Product Information XZI106

Part number identification on the steering column - Renault Modus (J77)

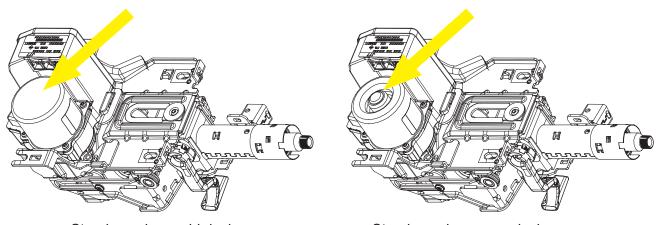
If the label shown in the following is attached to the steering column, this provides the relevant numbers for identifying the correct replacement part.
